Technical Bulletin

Board units change

GX17

2) Compatibility with Board units and SPST

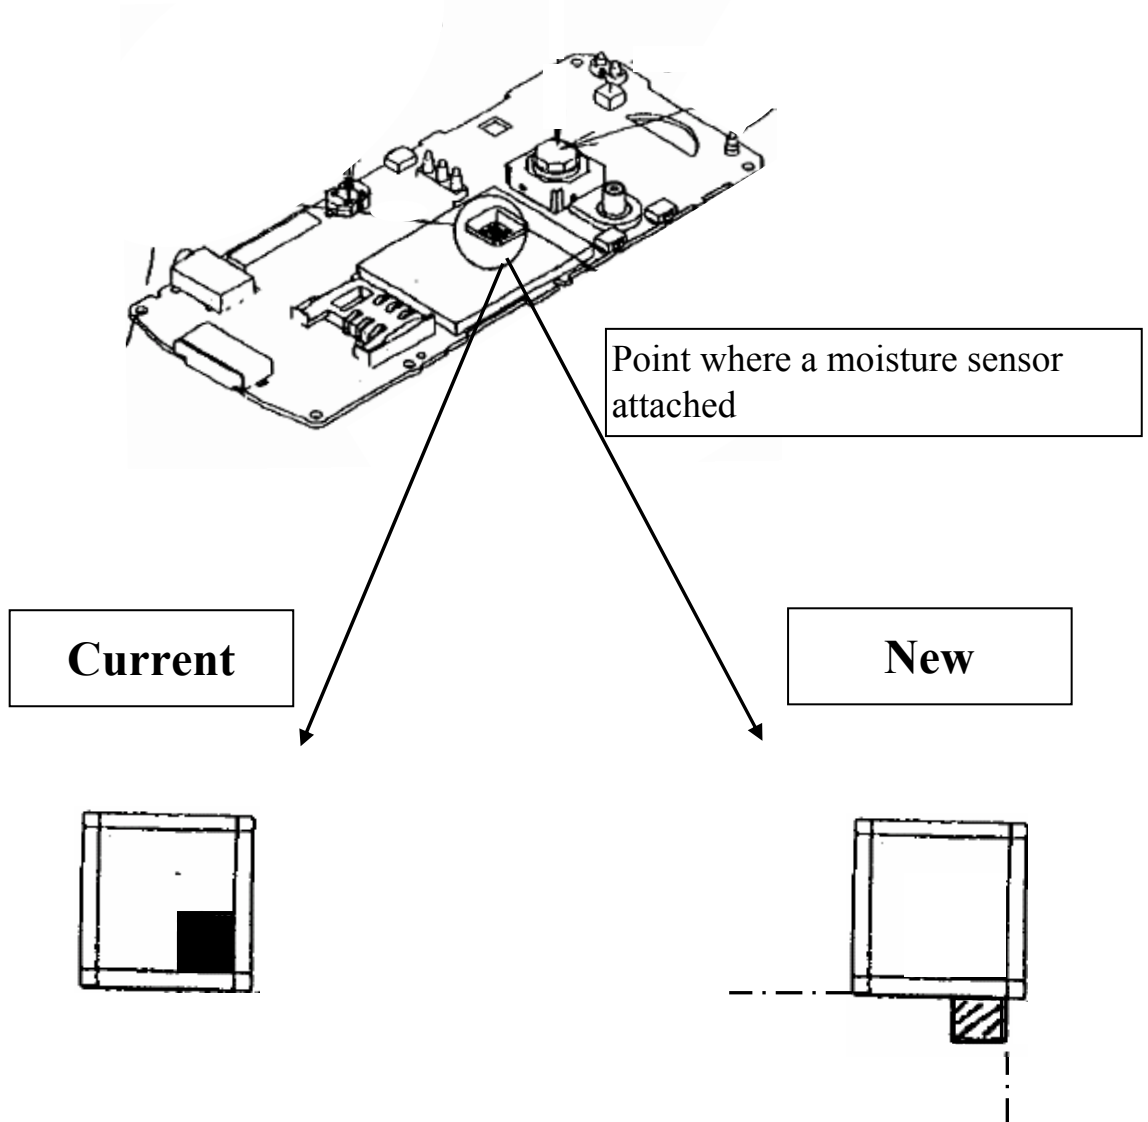
According to the change of GX17 board units, its firmware(software) has been also changed. Please perform services according to the following information.

Point where a moisture sensor attached should be different for new ones and current ones.
Parts code of the board units remain unchanged.

Notice) Board units include keyboards and it is compatible with one another on a unit basis ,
so you are not allowed to exchange only boards or keyboards between old and new board
units.

Board unit	Firmware(software)	Operation
Current	current	○
	new	○
New	current	×
	new	○
